Amendments to ECE/TRANS/WP.29/GRSG/2012/10

This document reproduces the amendments to ECE/TRANS/WP.29/GRSG/2012/10 as adopted by of the Working Party on General Safety Provisions (GRSG) during its one hundred second session.

Proposal adopted by GRSG:

Figure 1

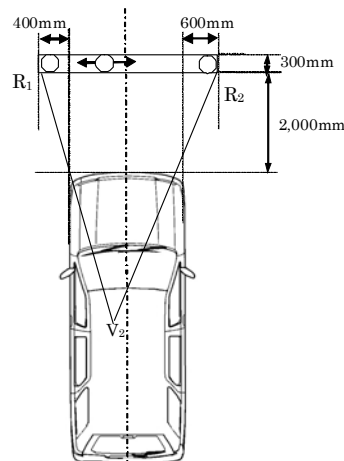
Insert a new paragraph 5.1.4., including new figures 1 and 2, to read:

- "5.1.4. In the case where the height of V2 above the ground exceeds 1,650 mm, the following requirement shall be met:**

A 1,200 mm tall cylindrical object with a diameter of 300 mm that is situated inside the space bounded by a vertical plane located 2,000 mm in front of the vehicle, a vertical plane located 2,300 mm in front of the vehicle, a vertical plane located 400 mm from the driver's side of the vehicle, and a vertical plane located 600 mm from the opposite side of the vehicle shall be at least partially visible when viewed directly from V2 (see figure 1), regardless of where the object is within that space, unless it is invisible due to a blind spot(s) created by the A pillars, windscreen wipers, or steering wheel.

Figure 2

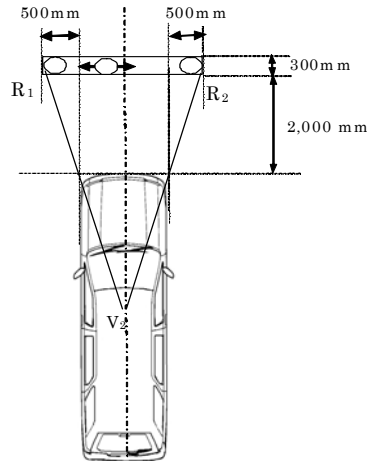
If the driver's seat is located in the central driving position of the vehicle, the 1,200 mm tall cylindrical object shall be situated inside the space bounded by a vertical plane located 2,000 mm in front of the vehicle, a vertical plane located 2,300 mm in front of the vehicle, a vertical plane located 500 mm from the side of the vehicle (see figure 2).
